MONTGOMERY COUNTY HISTORIC PRESERVATION COMMISSION STAFF REPORT

Address: 10210 Capitol View Ave., Meeting Date: 9/17/2025

Review: 1119303 **Staff:** Devon Murtha

Proposal: Fenestration alterations

Figure 6: Existing elevation (left) and proposed right/west elevation with location of proposed new windows (right). Note that the applicant is proposing a 6/1 window, not a 6/6 window.

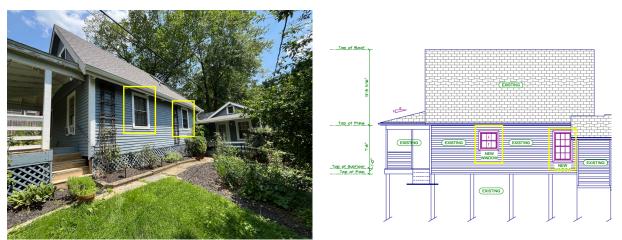
Staff notes that the drawings submitted by the applicant show a proposed 3/3 and 6/6 double-hung window. However, during a phone call with Staff on August 28, 2025, the applicant indicated that they were amendable to installation of a 6/1 window (as opposed to a 6/6 window) to match the profile of the existing and historic windows. The drawings have not been updated to reflect the amended proposal.

Staff finds that the proposed double hung wood windows are generally compatible with the historic character of the 1920s bungalow. However, Staff finds that a 6/1 profile is more appropriate than the

proposed 6/6 profile, as it matches the windows on the façade of the historic house and right/west elevation of the addition. Staff also finds that the 3/3 window is generally in keeping with the character with the resource, given that the house already features multiple historic window configurations that reflect the many twentieth century additions. Staff is also supportive of the 3/3 window, as opposed to a 3/1 window, and finds that the glazing divisions in the smaller opening better complement the profile of the proposed 6/1 window.

- 1. The applicant must submit window specifications to Staff to confirm that the proposed windows will be 6/1 and 3/3 double hung wood windows with 7/8" SDLs with a spacer bar.
- 2. The applicant will submit documentation confirming that the trim surrounding the new windows will be wood to match existing.

Figure 7: Plan view of alterations.

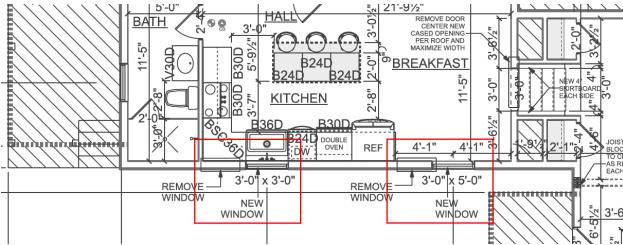
The applicant is proposing to relocate two window openings on the right/west elevation of the non-historic 1980s addition that currently hold 6/1 double-hung wood windows. The proposed window openings will hold double hung wood windows (*Figure 6*). Both new windows will be relocated immediately to the right of the existing windows (*Figure 7*). The proposed windows are Pella Lifestyle series with simulated divided lites.

ELEVATION 8/23/2025 RIGHT

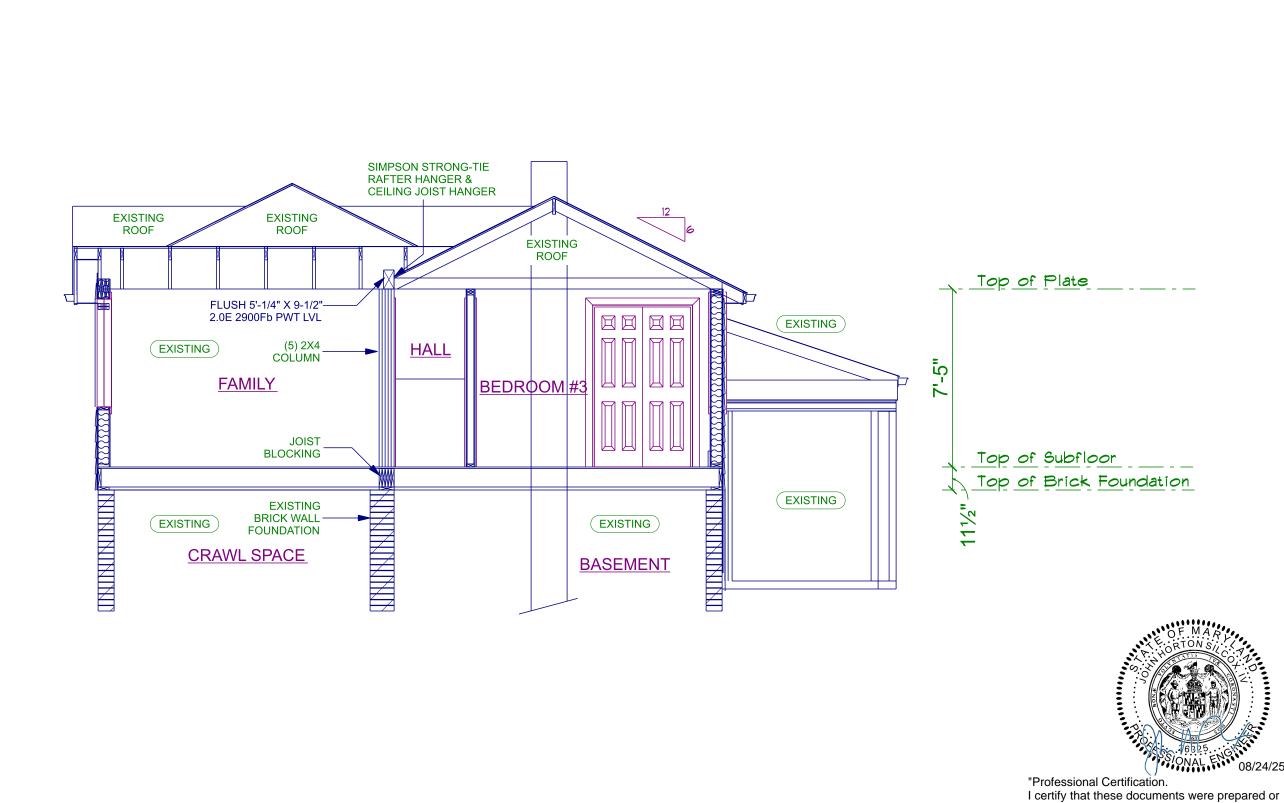
The applicants have not submitted accurate drawings to reflect the proposed changes, and Staff recommends that the HPC require that the applicant submit corrected material specifications as a condition of approval. The applicant also notes that all materials will be "in-kind," but does not specifically call out the material of the proposed window trim in the drawings. Staff recommends that the HPC require the applicant to confirm that the trim will be wood to match the existing as a condition for approval.

- 1. The applicant must submit window specifications to Staff to confirm that the proposed windows will be 6/1 and 3/3 double hung wood windows with 7/8" SDLs with a spacer bar.
- 2. The applicant will submit documentation confirming that the trim surrounding the new windows will be wood to match existing.
